Product Change Notification: PCN-23-174545

PCN Date: 18-MAY-23

Add the C angle to increase the guide

BEFORE CHANGE_36P

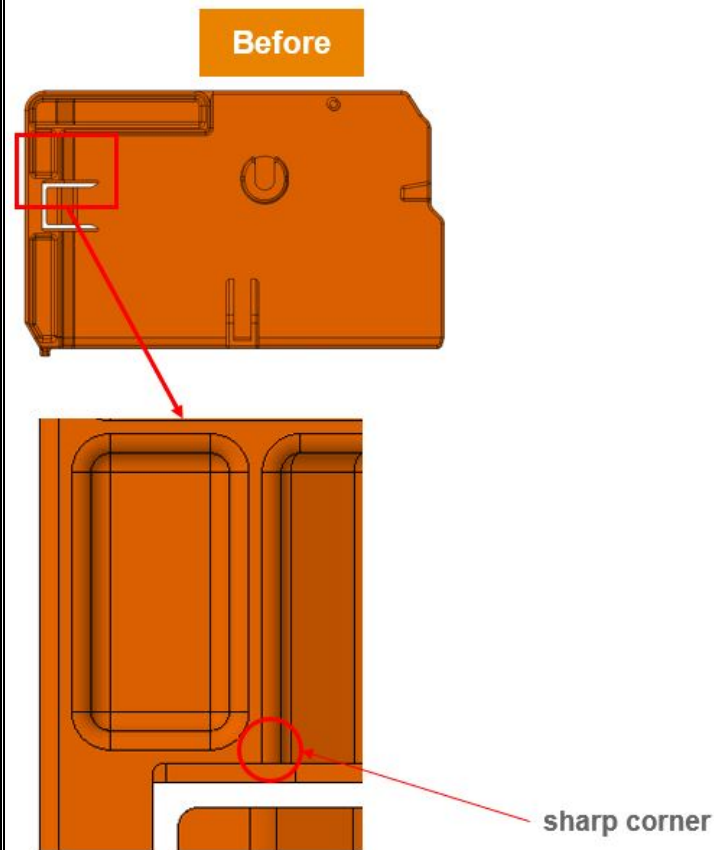
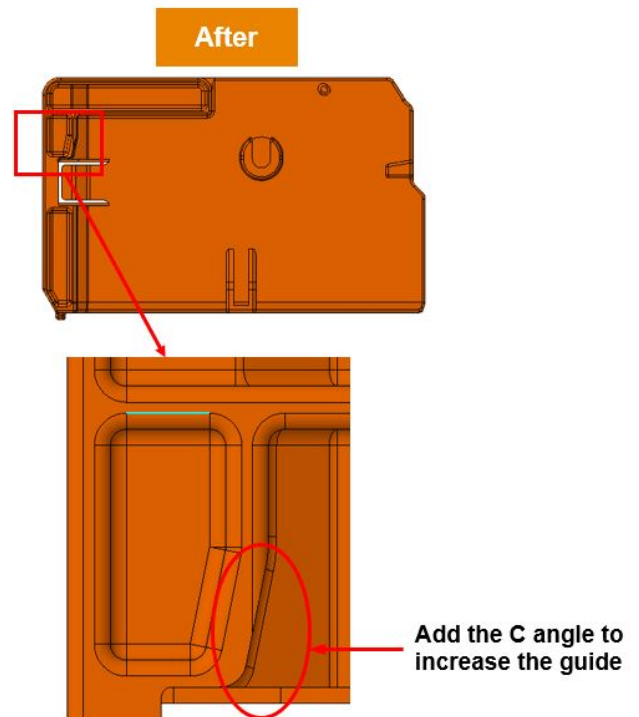
Dear Customer, in an effort to continuously improve our products, TE-ICT will update cover of the connectors. This change will not impact connector performance. IMPORTANT: This is a continual change so the current and previous revisions of the part can be used interchangeably in the field. This change is being phased in gradually and previous revisions may remain stocked until use up. Shipments of both configurations may be mixed. Before: 36P Plug housing is sharp corner near TPA gap After: 36P Plug housing is C angle near TPA gap

AFTER CHANGE_36P
